***Replace 115 kV Circuit Breaker at David Bell mine  
Notification of Conditional Approval of Connection Proposal  
CAA ID Number: 2006-EX311***

## ASSESSMENT SUMMARY

### Teck-Corona Operating Corp.

Figure 1: David Bell mine

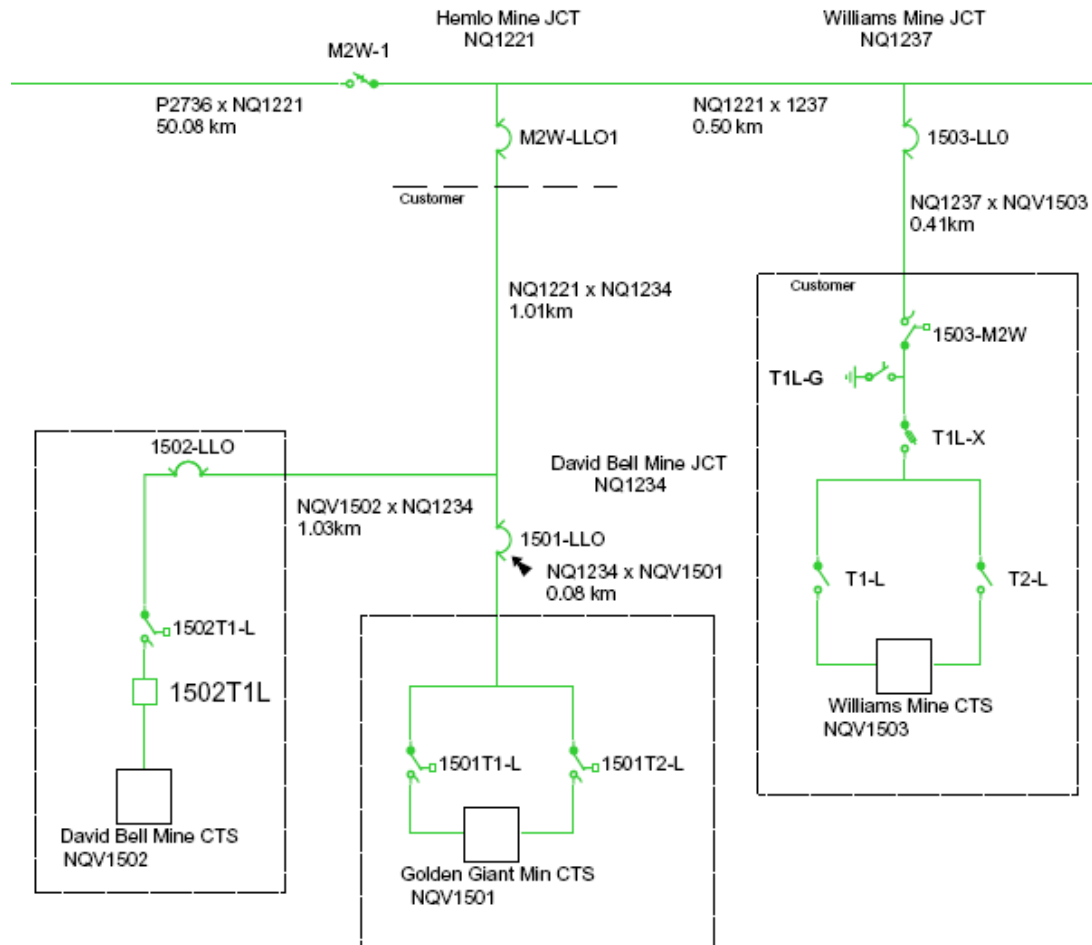
Teck-Corona Operating Corp. is proposing to replace the 115 kV circuit breaker 1502T1L at the David Bell mine near Marathon. The expected in service date is July 2, 2007. The existing configuration is shown in Figure 1.

The Teck-Corona David Bell Mine located near Marathon, Ontario is connected to the Hydro One 115 kV M2W transmission line. The mine is preparing to undertake to replace their present 138 kV, 1200 Amp oil-filled main circuit breaker with a new SF6 circuit breaker in the spring of 2007. The circuit breaker designation is 1502T1L.

The Transmission System Code (TSC) indicates that the transmission system has to be designed to sustain short circuit currents of 50 kA for the 115 kV system. The circuit breaker noted above is underrated if the neighbouring transmission systems experience maximum fault levels.

Teck-Corona Operating Corp. must ensure that the short circuit current seen by this circuit breaker does not exceed the short time rating of the new equipment. If any future system enhancements in the area result in short circuit levels higher than the capability of the new circuit breaker, Teck-Corona Operating Corp. is required to replace the new equipment with higher rated equipment.

The proponent must notify the IESO as soon as it becomes aware of any changes to the assumptions made in the connection assessment. The IESO will determine whether these changes require a re-assessment.

If any future system enhancements in the area result in short circuit levels higher than the capability of the new circuit breaker, Teck-Corona Operating Corp. is required to replace the new equipment with higher rated equipment.

Teck-Corona Operating Corp. is required to meet requirements with respect to protection systems for the replacement circuit breaker and coordination with the existing protection systems, as outlined in the Transmission System Code.

The Market Rules (Chapter 4 section 7.4) require that each connected wholesale customer shall provide the IESO on a continual basis with on-line monitored status as specified in Appendix 4.17. Teck-Corona Operating Corp. will be required to meet the IESO's on-line monitoring requirements.
